Item: 6a) REPORT 18-0616 CONSIDERATION OF ALTERNATIVE LOCATIONS FOR THE GREENBELT INFILTRATION PROJECT (Environmental Analyst Kristy Morris)

Subject: Concern Regarding Liquefaction

Subject: Greenbelt Infiltration Project between Herondo and 2nd Street – Groundwater Issue,
Updated Letter

Figure 3 – Slide from Tetra Tech, June 19th Presentation

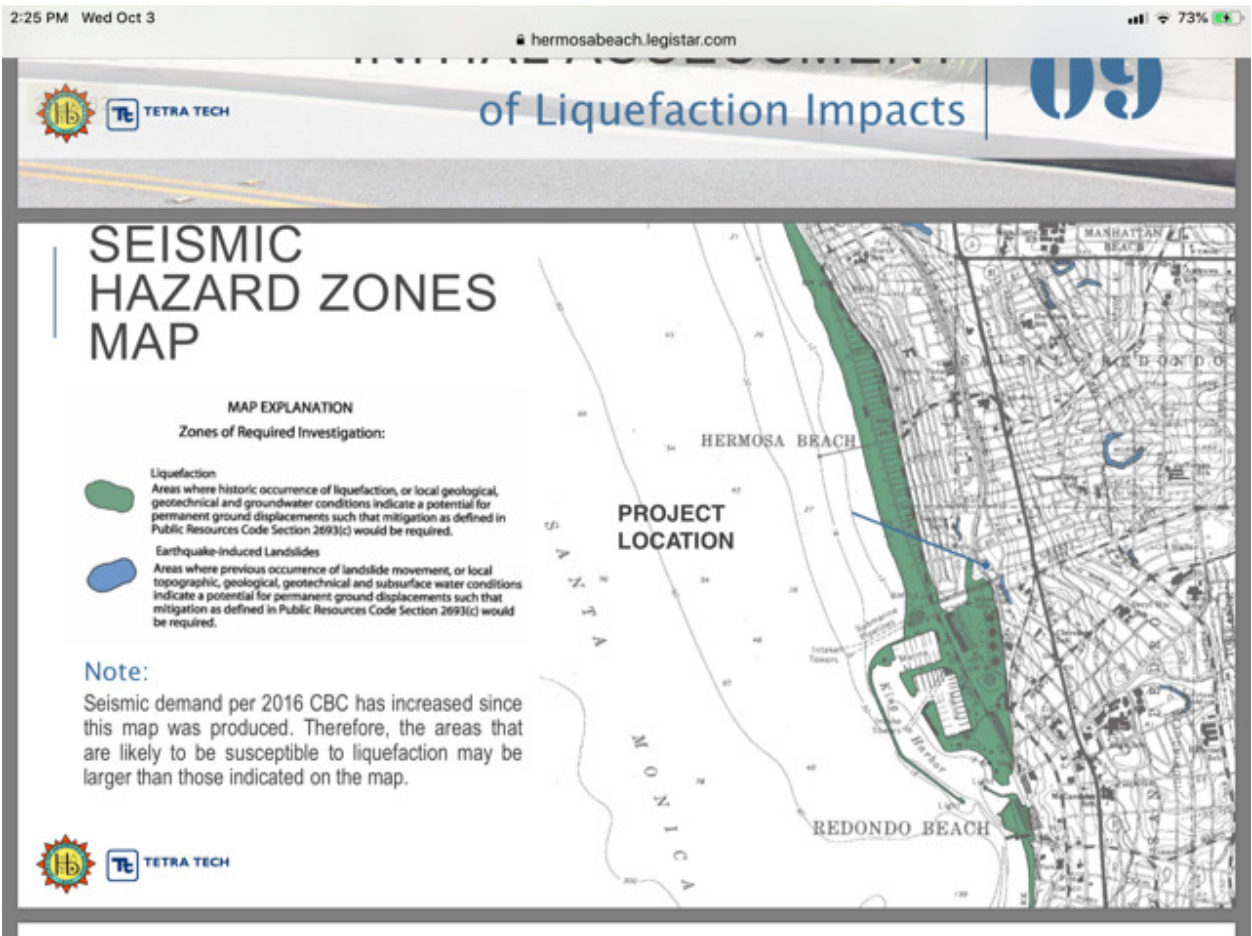
The regulations are not specific in terms of what is a significant increase to risk. The 0.25' values gives us a target for what is "significant" for adjacent structures. The Tetra Tech presentation slide reproduced as Figure 3, shows a value of 0.5 feet. Keep in mind the Tetra Tech reported a preliminary number based on assumptions which have not been shared with us. As outlined above, the assumptions are critical because of the non-exact nature of this type of analysis. Additionally, the rise in the groundwater level due to the infiltration will increase the likelihood of adjacent property subsidence, even excluding an earthquake event.

Incidentally, referring back to Figure 3, Tetra Tech mentions "conservatism" in one of the bullet points and the arguments in support of their observation that there is "conservatism". Let me be clear about this, the Building Codes do not allow this type of "hand waving" to rationalize design deficiencies because there are "conservatisms". Yes, the Code based the major design earthquake is intended to be a once in 2,500 year event. So the chances are remote that it will strike in our life time. However, we must design for earthquakes, with understood "conservatisms", because the consequences of not doing so are catastrophic. The regulations are specific, and must be met.

Figure 1 – Historic High Groundwater Level

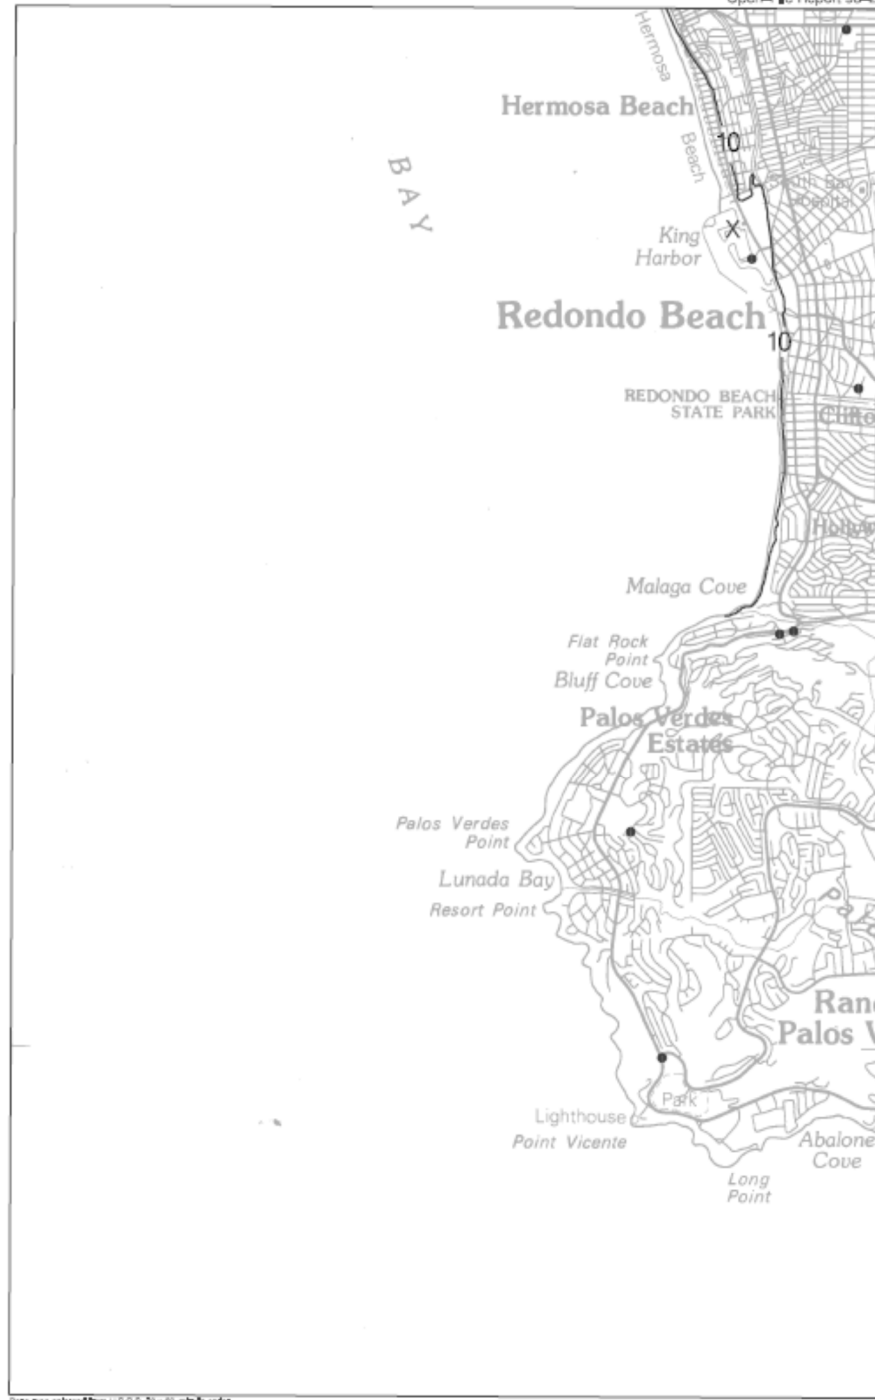
The historic high groundwater level for the proposed Greenbelt infiltration project location is only 10 feet below ground surface level. This is documented in reference #4, report plate 1.2 (see Figure 1 of this letter). The use of historic groundwater level would not allow for an infiltration project. The regulations go on to say that “existing groundwater data may also be used to verify the seasonal high groundwater elevation is greater than 10 feet...”. The definition of seasonal high groundwater level is “The elevation to which the ground or surface water can be expected to rise due to a normal wet season.”

Figure 2 – Groundwater Well Close to Proposed Project (Well 704E is nearest)

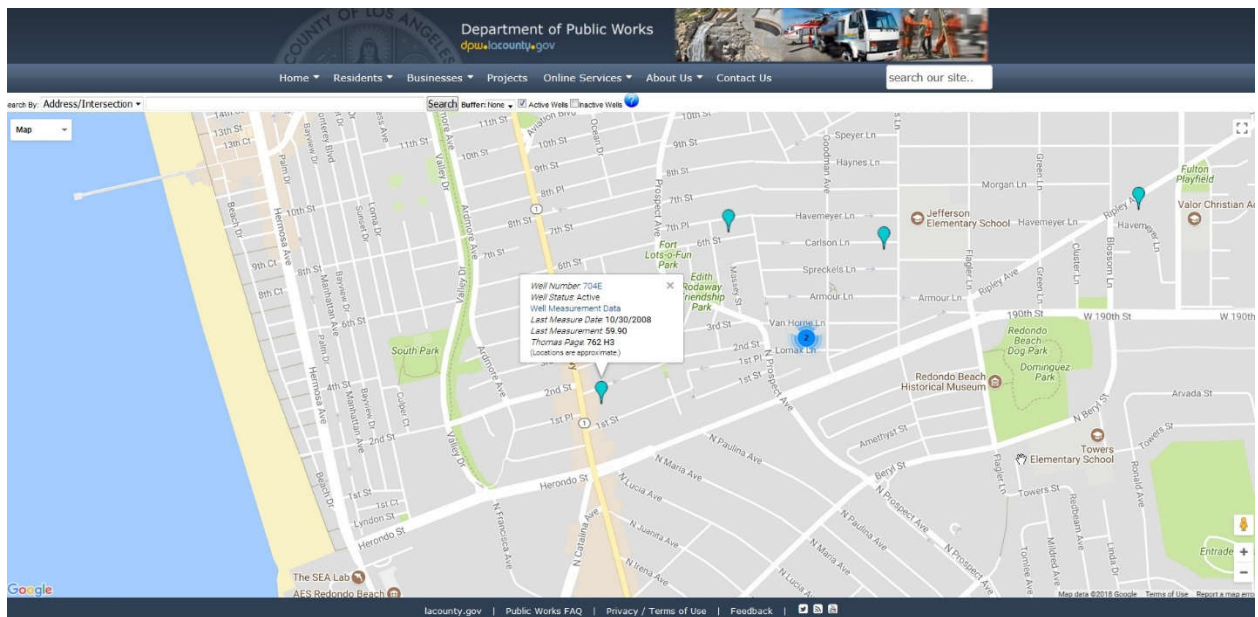
Well 704E is located East of PCH, between 1st Street and 2nd Street (Ref. 6). Figure 2 of this letter shows the location of well 704E. The last measurement date for this well is 10/30/2008. The reason this well is important is because it is the closest well with detailed information regarding historic groundwater elevations pertinent to the Greenbelt Infiltration Project. Simply put, the error occurred because Tetra Tech did not realize or account for the fact that Well 704E is NOT located at the same elevation as the Greenbelt.

Figure 3 – Groundwater Level from Well 704E

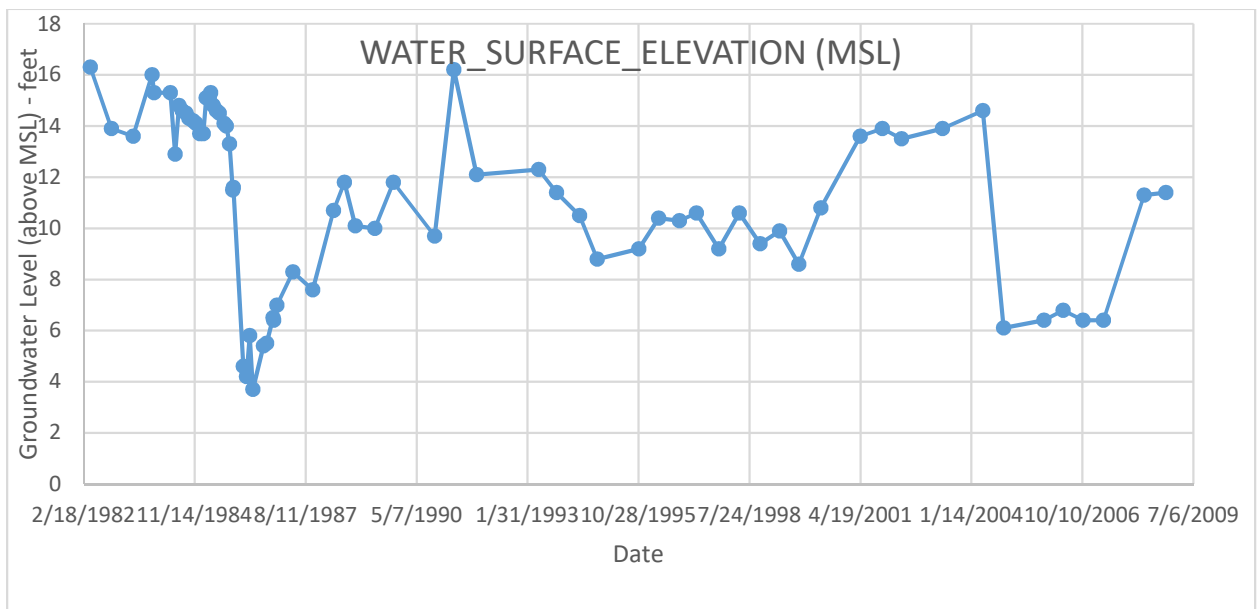
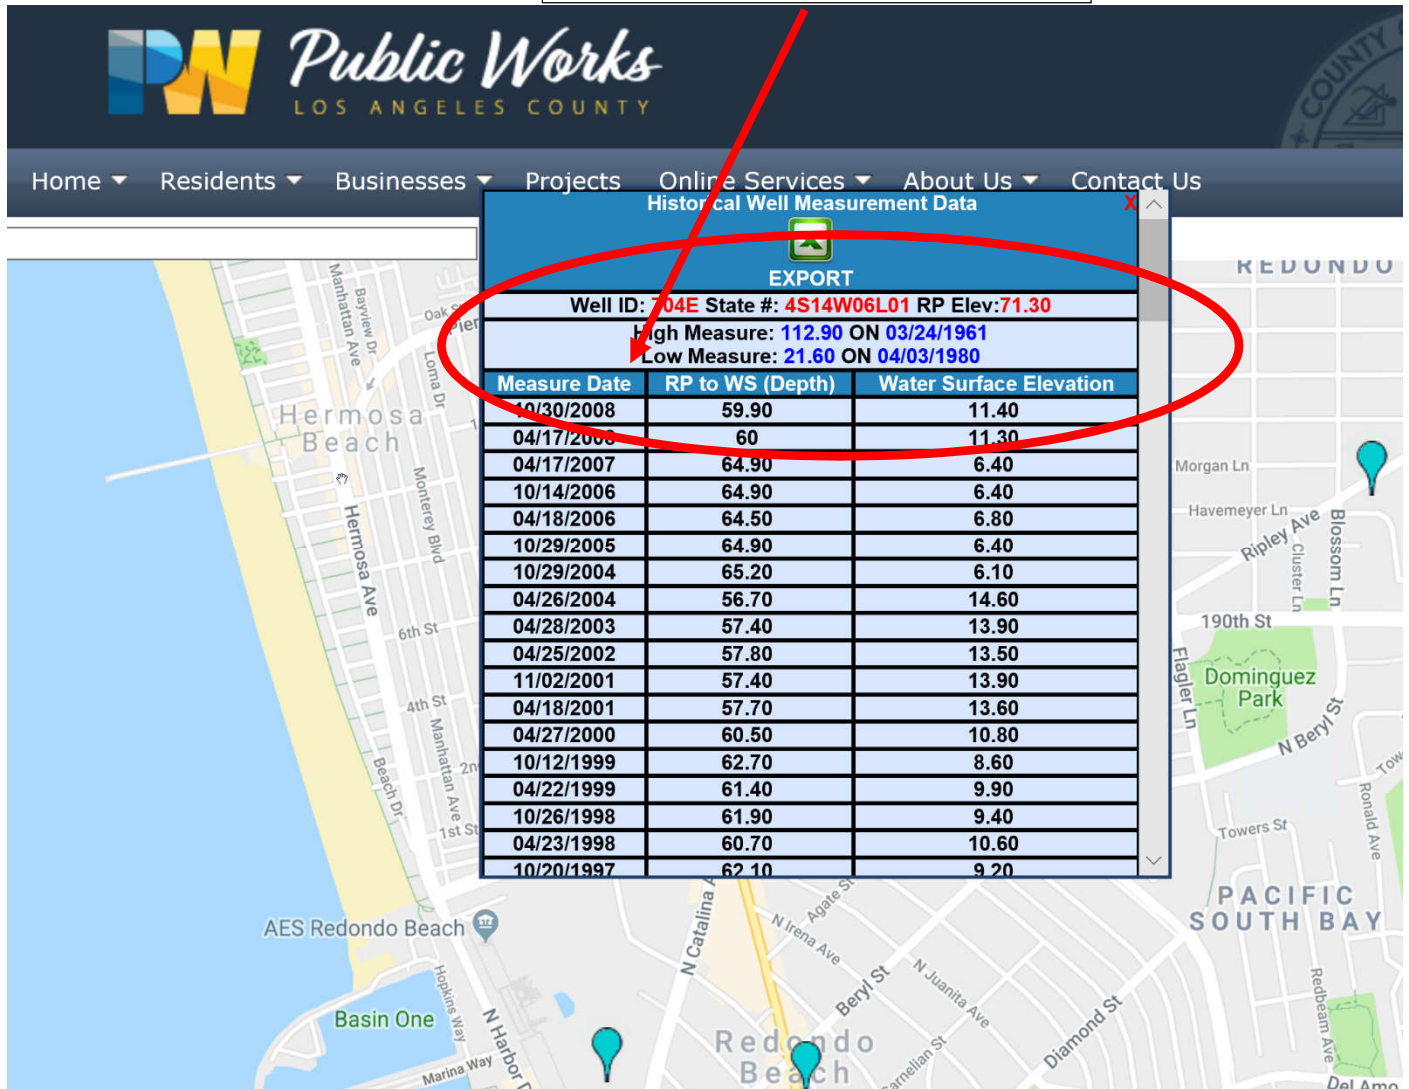
A much simpler, and correct measure is to extrapolate historic groundwater levels for the Greenbelt site based on the well data further up the hill is to look at the right column of Figure 4, titled “Water Surface Elevation”. The values in this column are simply the difference between Reference Point Elevation (71.3’) and the middle column values (subtract middle column numbers from 71.3, to match the right column values). Figure 3 of this letter shows the historic Water Surface Elevation at Well 704E.

The Greenbelt’s shallowest depth (ie highest Water Surface elevation) in Figure 3 is shown to be 16 feet above Mean Sea Level (MSL). This depth has occurred on multiple occasions since 1982. With the Greenbelt ground surface elevation being at approximately 30 feet (above MSL), the historic shallowest groundwater elevation is: $30 - 16 = 14$ feet below ground surface (bgs). To restate, interpretation of the Well 704E data shows that the Greenbelt’s historic high groundwater elevation is 14’ bgs, not 21.6’ bgs reported by Tetra Tech.

Figure 4 – Well 704E Screen Shot of Dept. of Public Works Website [Ref. 6]

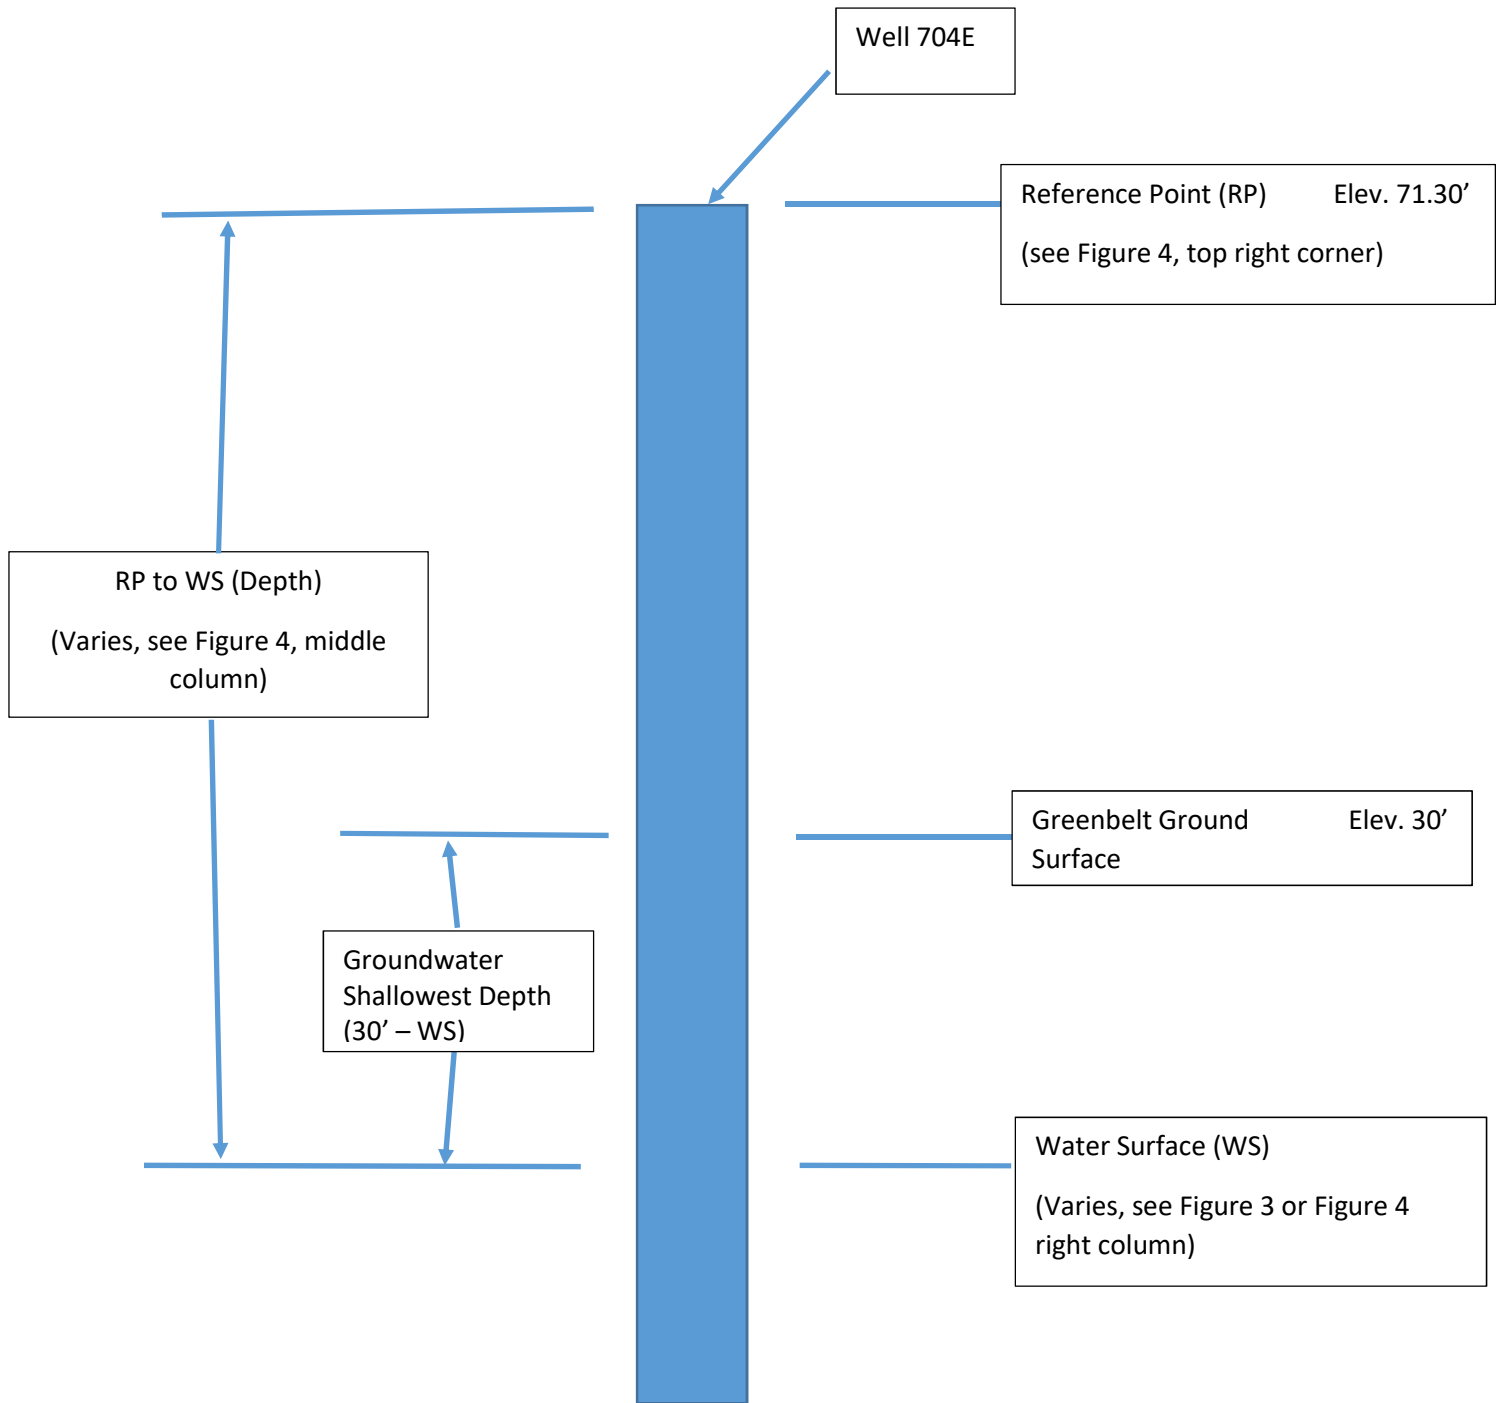
As any Hermosa resident knows, you have to climb a hill to get from Valley, where the Greenbelt is located, to PCH, where Well 704E is located. The proposed project site is approximately 40 feet lower in elevation than the well site. A screenshot of the data used by Tetra Tech is shown in Figure 4. The “Low Measure: 21.6 ON 04/03/1980” is highlighted. An illustrative guide to reading the well data is provided in Figure 5. The value used would have been correct if the Well 704E reference point elevation and the Greenbelt elevation were the same. But they are not. Figure 4 clearly shows that the Reference Point (RP) Elevation is 71.30’. The Greenbelt ground elevation is approximately 30’.
